Integration of additional BPM in BI line

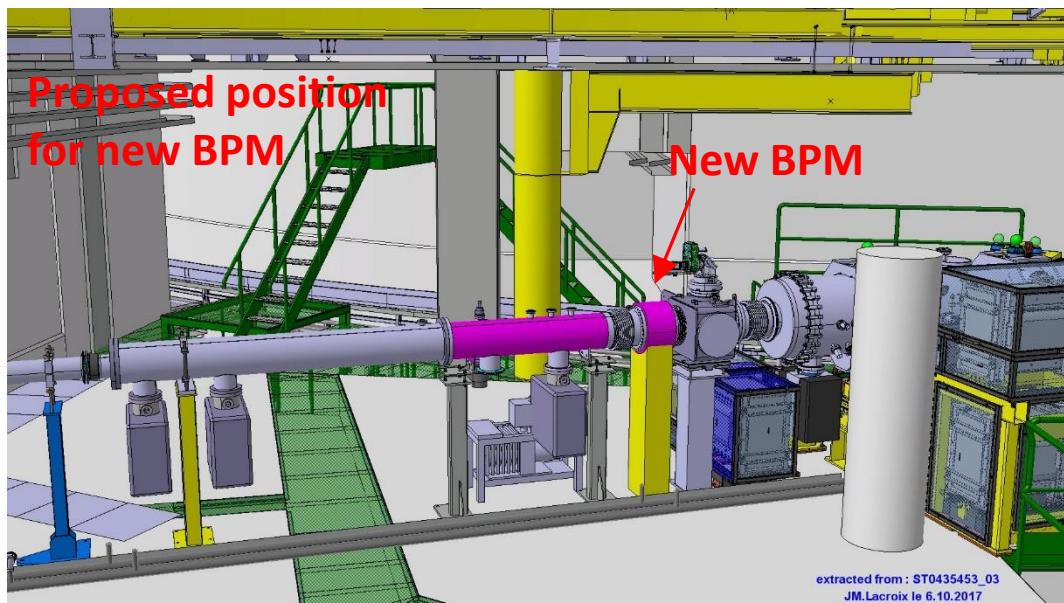
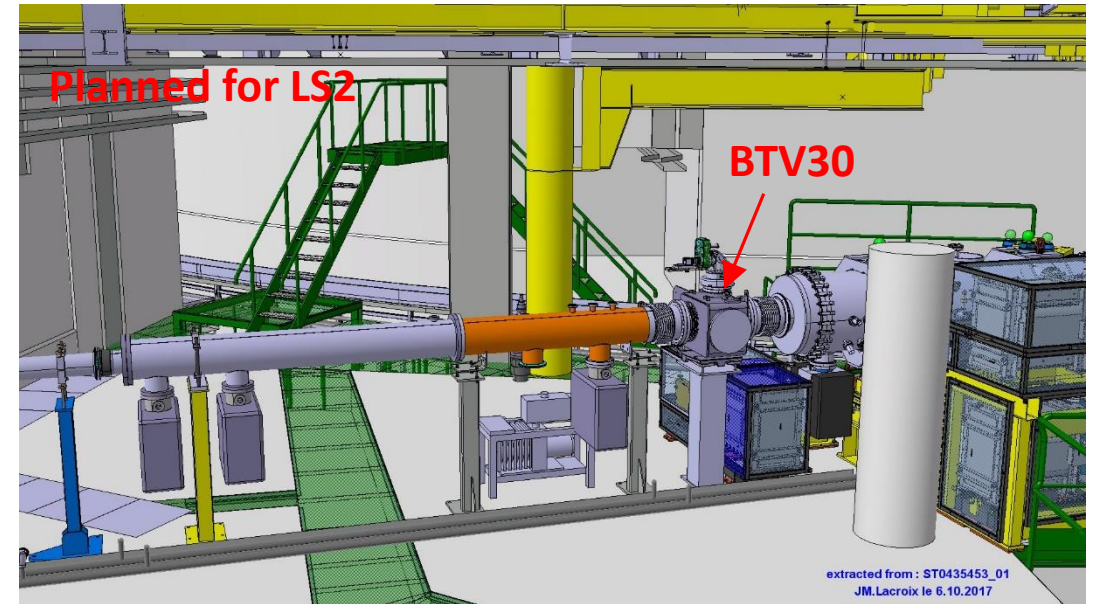
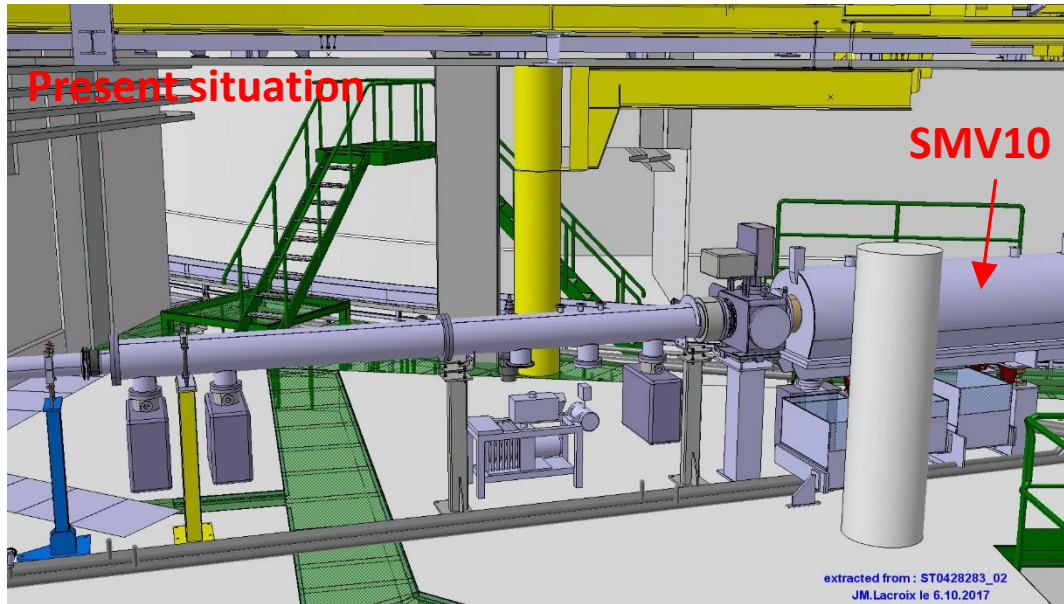
- New BPM to be installed as close as reasonably possible upstream SMV10.
- Chamber upstream BTV30 is anyway foreseen to be cut for LS2 changes.
- Proposal: Cut 220 mm more for BPM and install BPM upstream of BTV30.
- Proposal to be presented in ICL meeting on 18.10.
- Advice from TE-VSC needed.
- Space reservation request in preparation.
